Technical Service Bulletin

BULLETIN PA007-11

INSTALLATION RECOMMENDATIONS FOR TIMING BELT SYSTEM ON HONDA 1.7L ENGINES

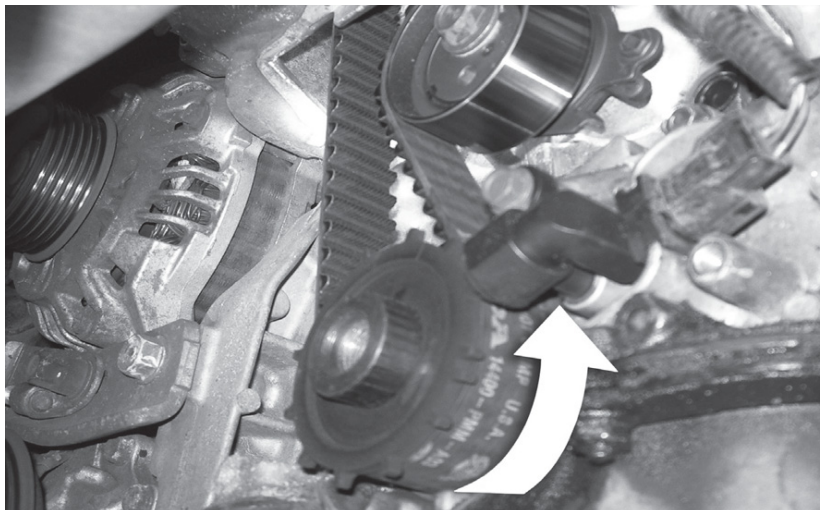
Below is the result from improper belt setup. Notice the damaged spring, this is the result of turning the crankshaft clockwise during initial setup, which is incorrect.

See installation instructions provided in this kit. Crankshaft must be rotated two turns **COUNTERCLOCKWISE** with locking pin in tensioner and attachment bolt loose.
